Proposed Extension to Eton Business Park, Eton Hill Road, Radcliffe

Transport Note 2

Hamilton Heath Estates Ltd

- 1.1.8 The purpose of this Transport Note 2 (TN2) is to address the highways and transport related comments provided by the LHA, GMFRS and TfGM.

Site Plan as Proposed SK01

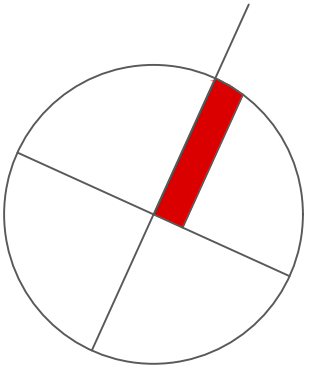
- The Council points you to the provide two car parking spaces per unit and separate parking provision for visitors and vans making deliveries to the proposed units.
- Access for the Fire Service is not achievable – see their response online and section below.
- Lack of Waste Management details and no refuse collection area. Refuse collection wagons are all larger than the large van tracking which has been undertaken. Please provide both tracking details for the refuse collection vehicle, a Waste Management Statement and the plans will need to be amended to provide a sufficiently sized refuse collection area.

- The LPA notes that the Proposed Site Plan does not have a key, therefore it is unclear how many car parking spaces are actually proposed. It seems to me that the Transport Note may not correspond with the submitted Proposed Site Plan.
- Please also address all of the comments and recommendations made by Transport for Greater Manchester (TfGM).

- 1.1.9 The revised site layout is contained in **Appendix 3**. This shows:
- 17 Industrial Units (B2 / B8 land uses) with a combined floorspace of 553 sqm.
 - 19 car parking spaces (including 2 blue badge spaces) dedicated to the start-up units. Whilst these are dedicated to the start-ups, they are communal across the start-ups. i.e., not 1 space per unit.
 - 7 existing formal parking spaces, associated with the wider industrial estate, which are to be removed to facilitate the proposals.
 - 6 car parking spaces for the wider industrial estate, to replace the existing spaces to be removed.
 - 2 cycle parking spaces.
 - 2 motorcycle parking spaces.

- 2.1.21 As can be seen from **Table 2.2** and **Appendix C**, the revised site layout provides the requested 17 standard car parking spaces, for the 17 units, albeit they are unallocated. The revised proposals therefore accord with the LHA comments. This provision is 70% higher than the Council’s maximum car parking standards.

- 3.1.1 This section addresses the LHA comments relating to tracking for the proposed site layout.
- 3.1.2 The proposed site layout contained in **Appendix 3**. The site layout has changed due to the provision of additional parking spaces.
- 3.1.3 Given the comments from the LHA and revised site layout, tracking has been carried out with:
- A large box van
 - A refuse vehicle
 - A fire appliance.

Sheet Title
**Proposed Site Layout: Swept Path
Analysis - Fire Appliance Entering
the Site**

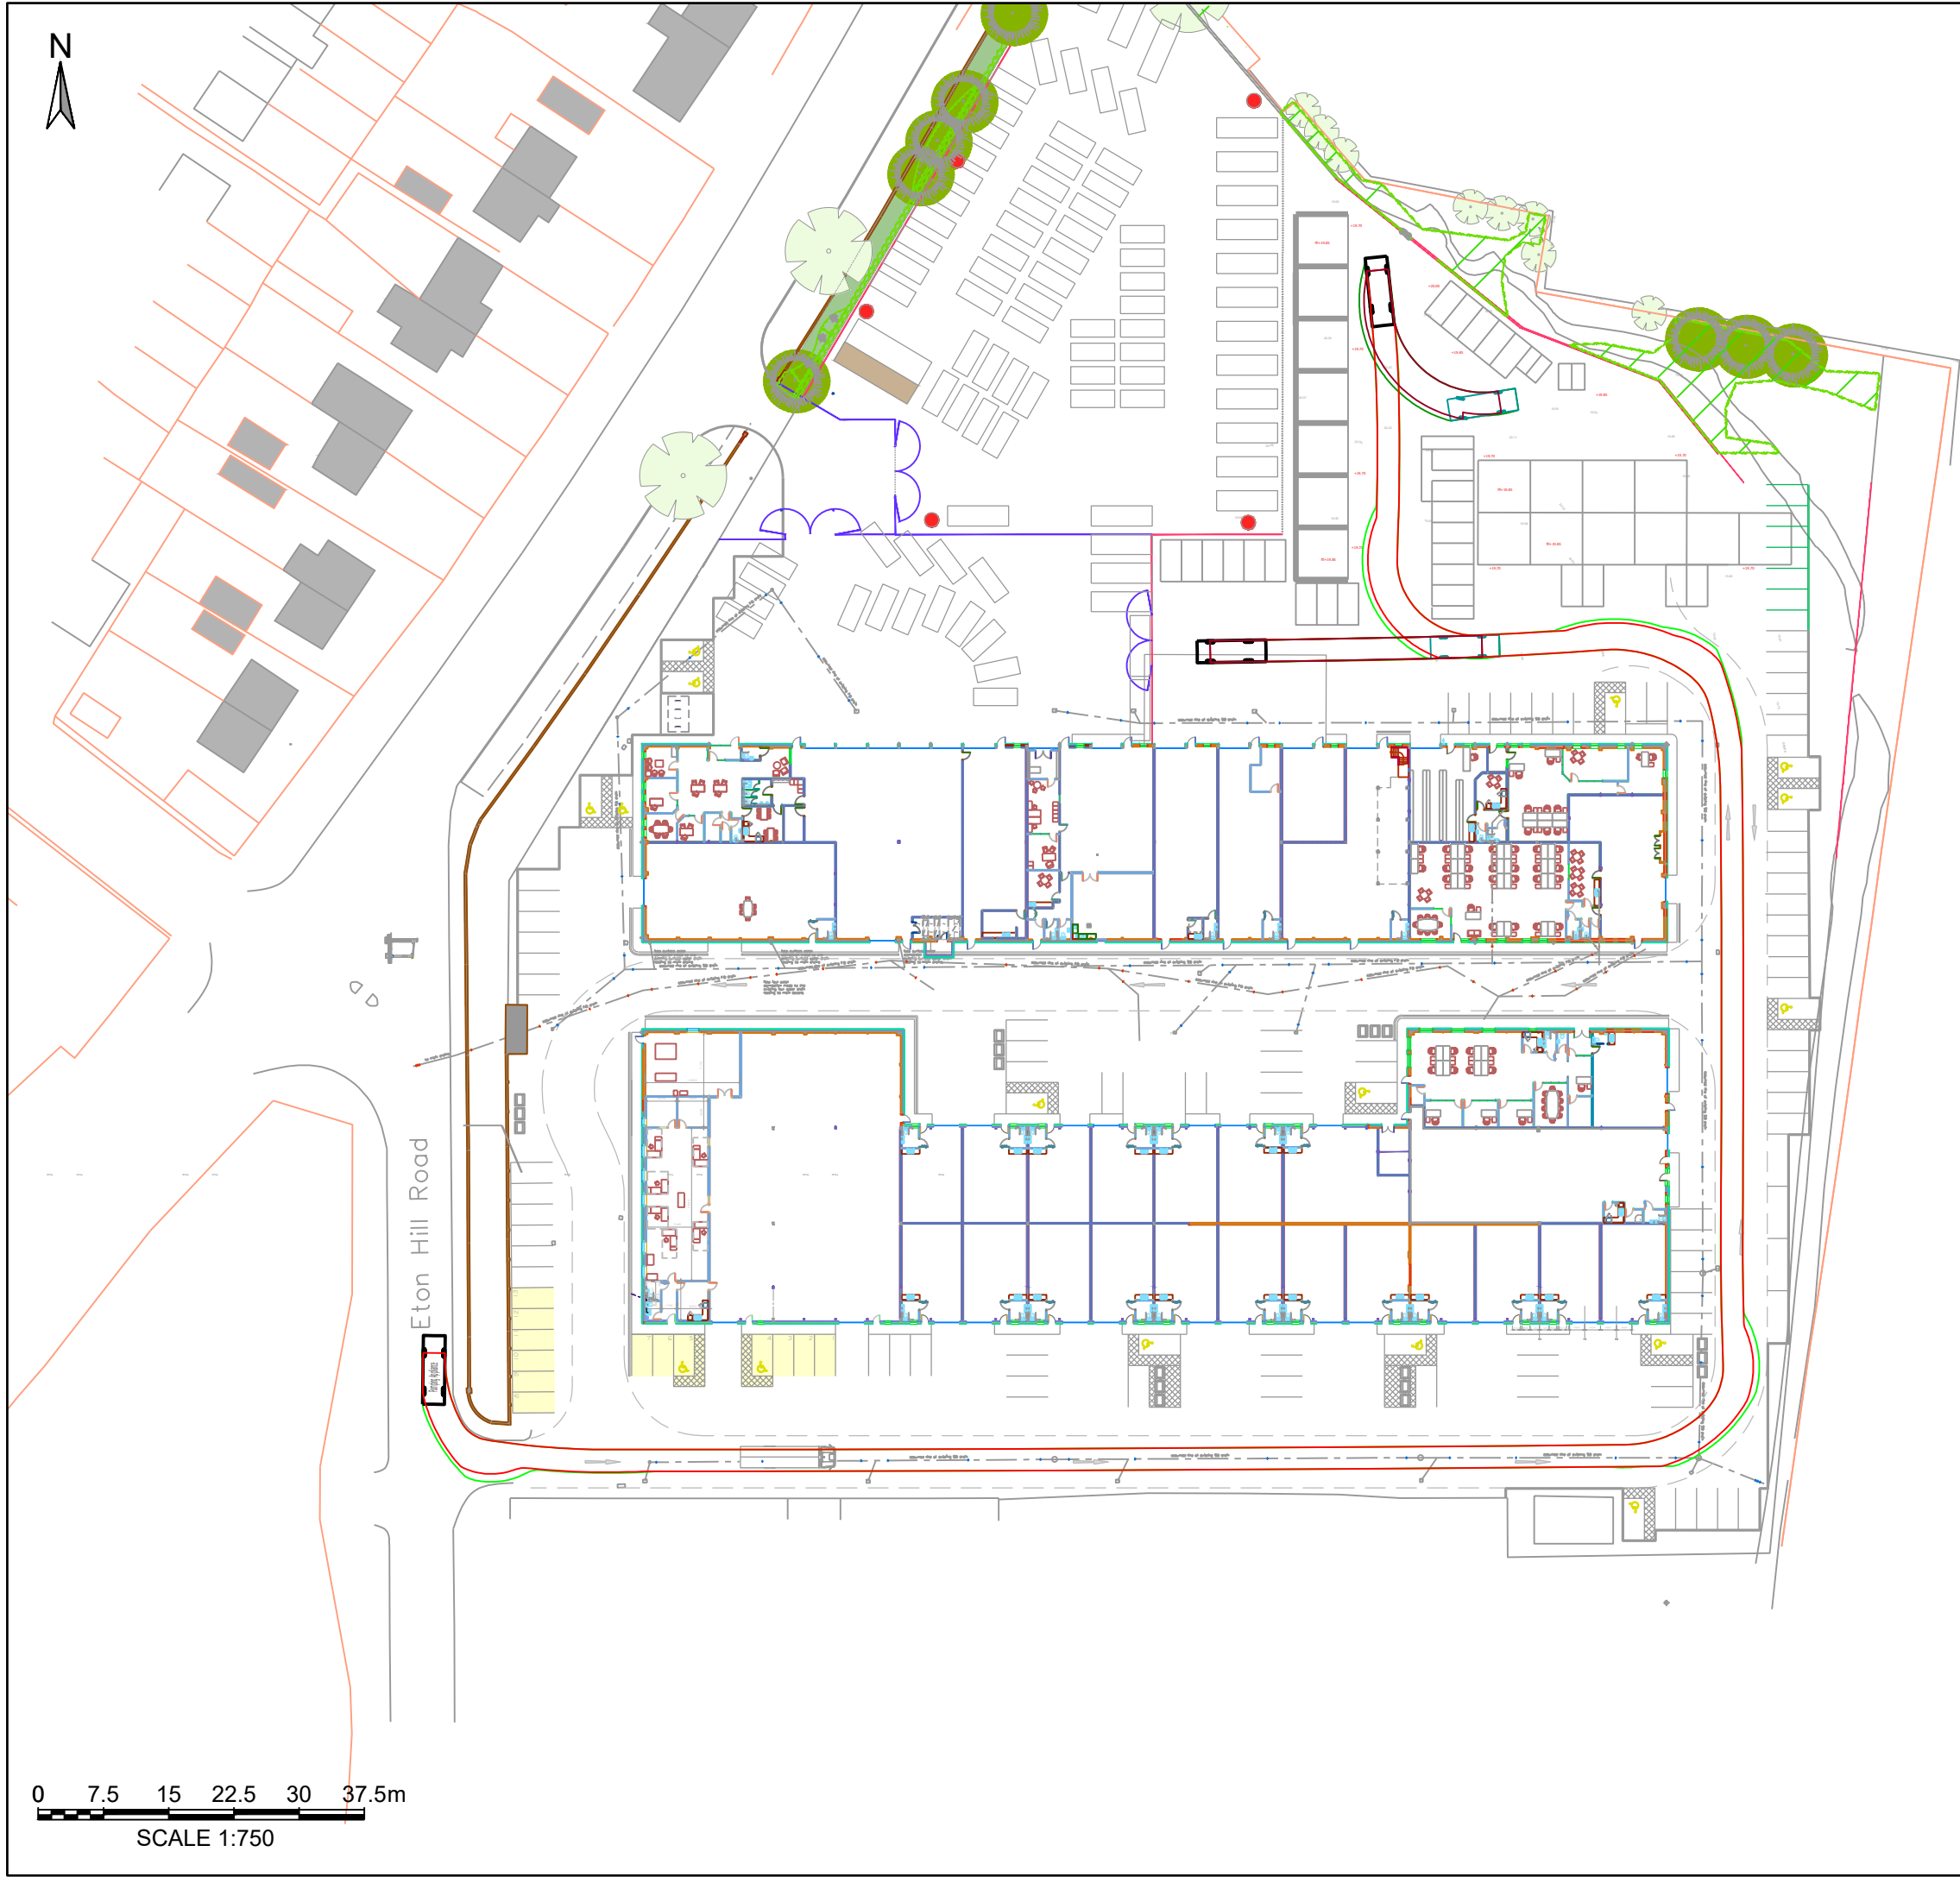
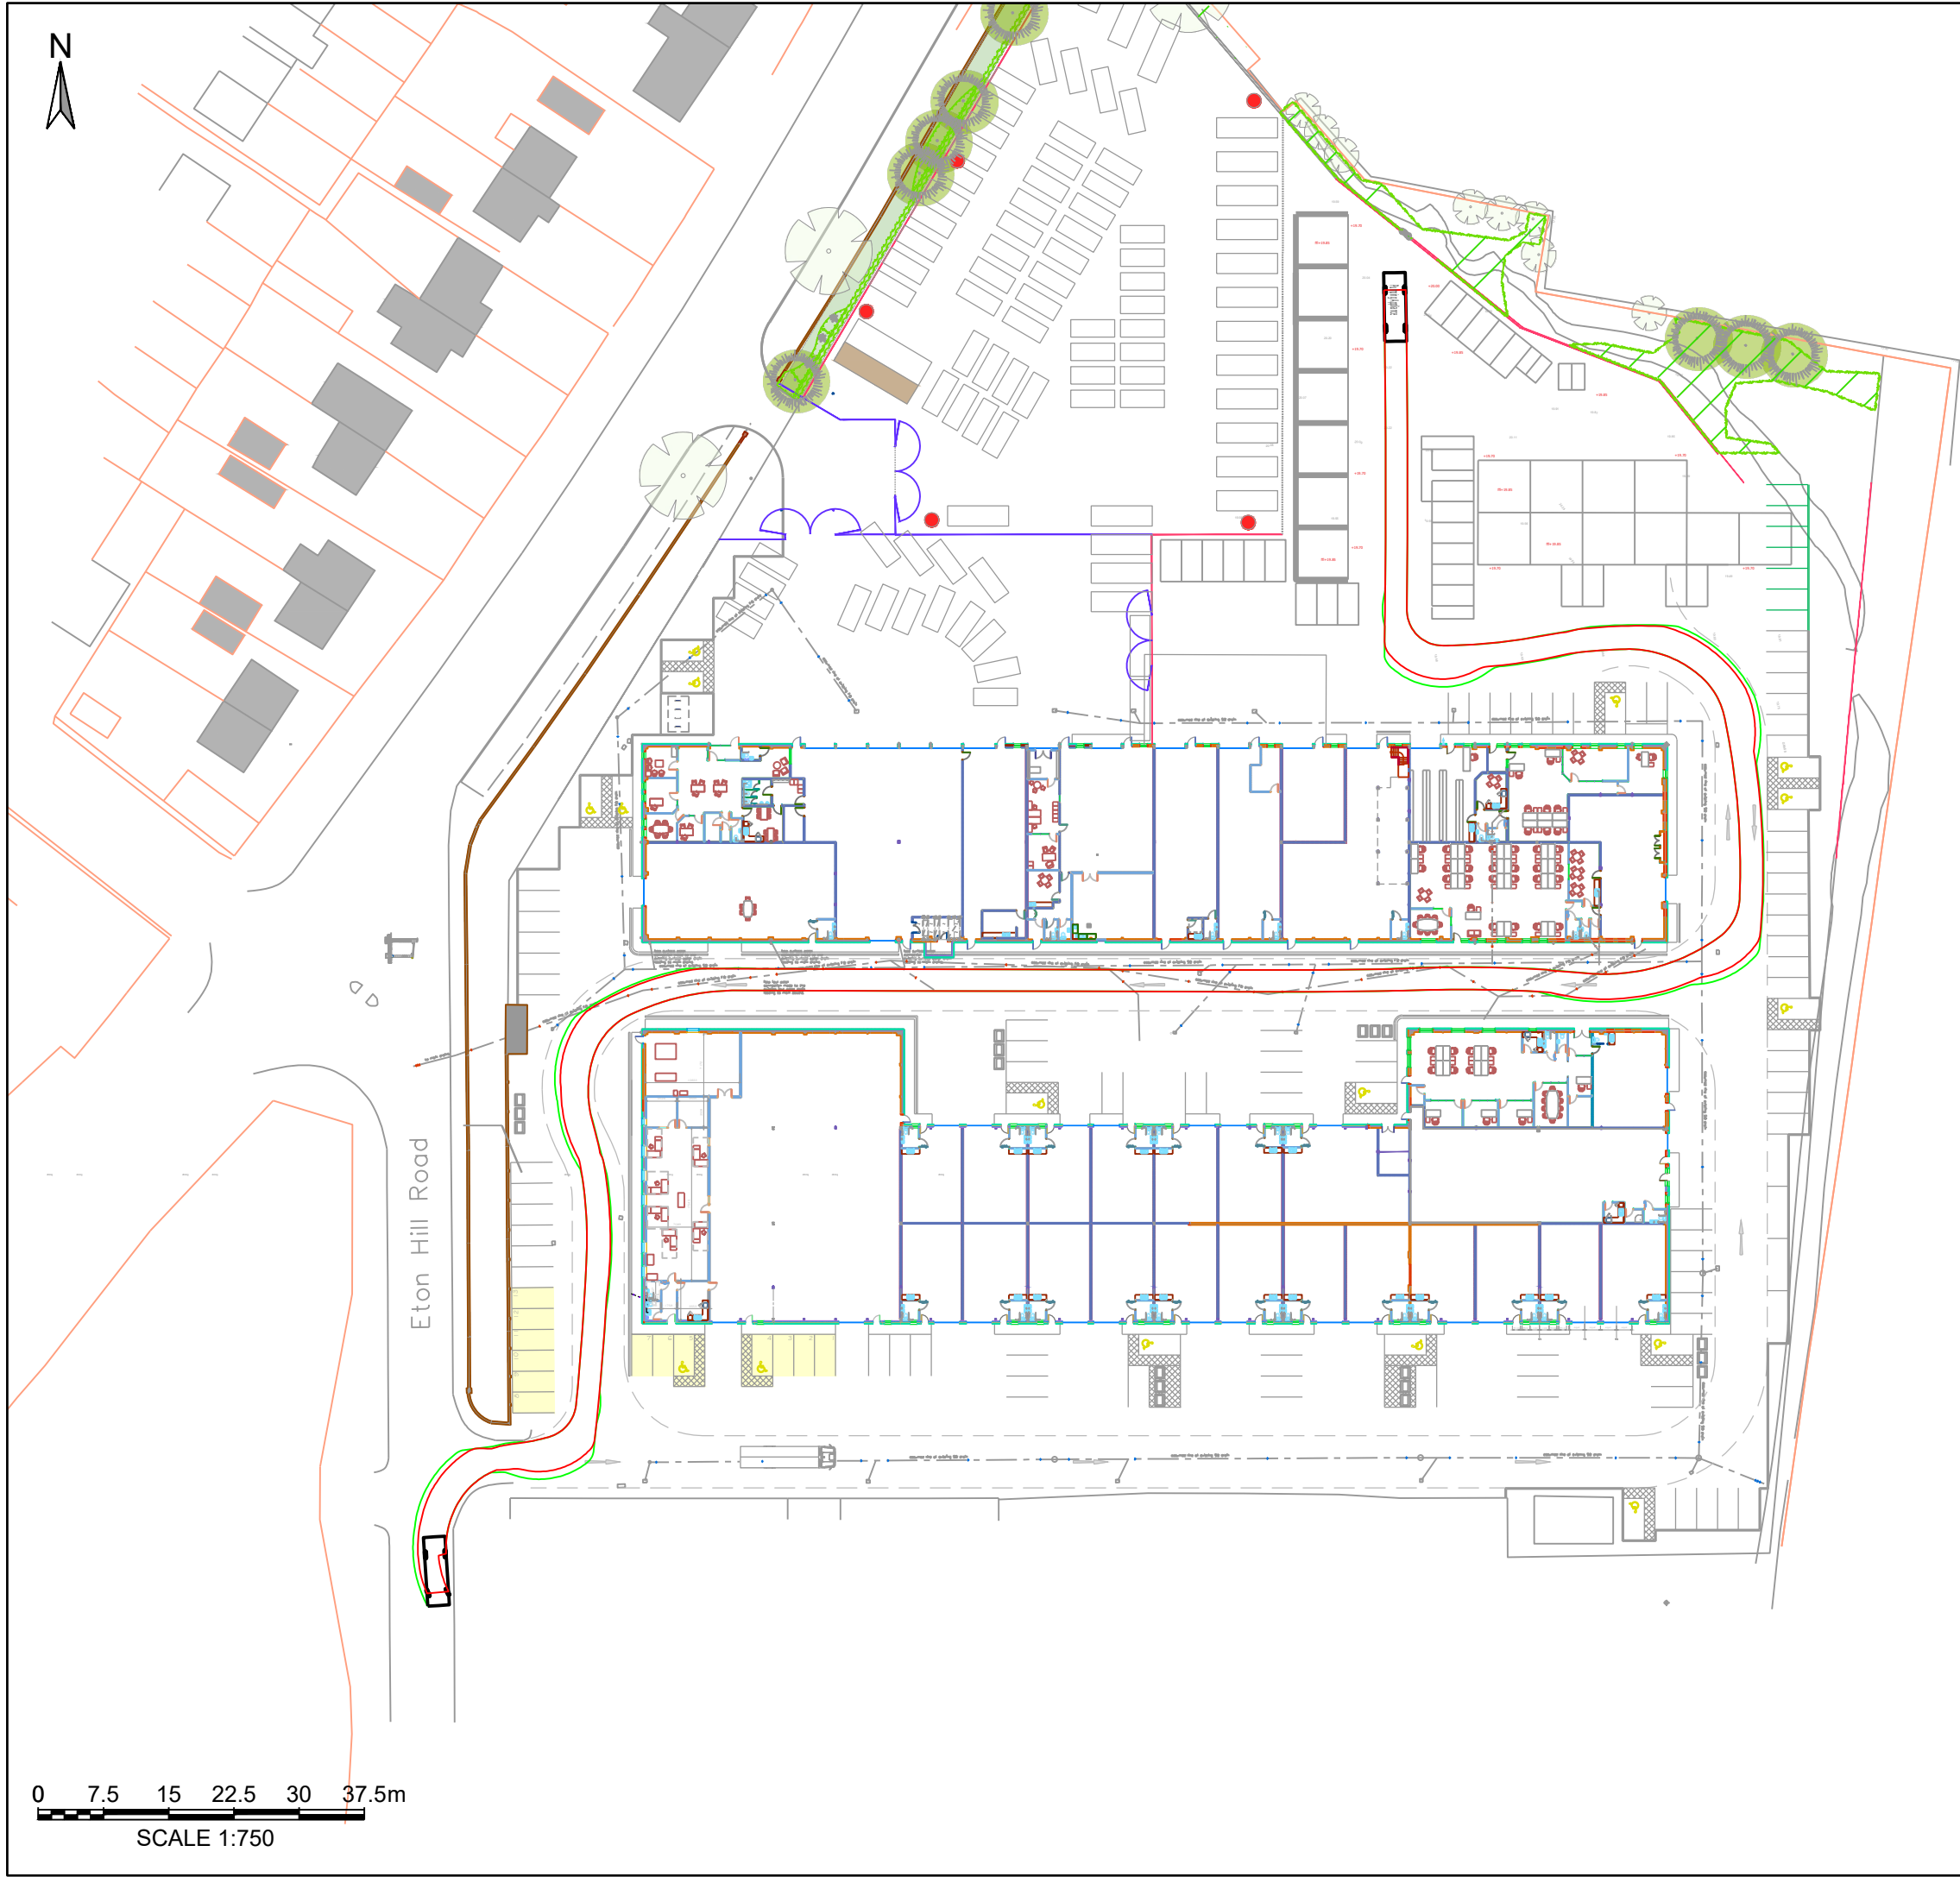
Please see the response from Greater Manchester Fire and Rescue attached. As it stands the site and its lack of access for a fire engine would render the site unsafe for future occupants. The application cannot be supported on this basis.

As a minimum vehicular tracking needs to be provided to demonstrate the fire service can enter and leave the site in a fire engine and access all proposed units, and a water hydrant needs to be provided close to the site.

- 3.1.8 The typical standard size of fire engine used by Greater Manchester Fire and Rescue Service (GMFRS) is 7.9m pumping appliance, which is less onerous than the 8.9m long refuse vehicle, see above.
- 3.1.9 **Appendix 6** shows tracking with this fire appliance, as can be seen from the tracking the vehicle can easily access the proposed units.
- 3.1.10 A water hydrant will be provided close to the site, if necessary.
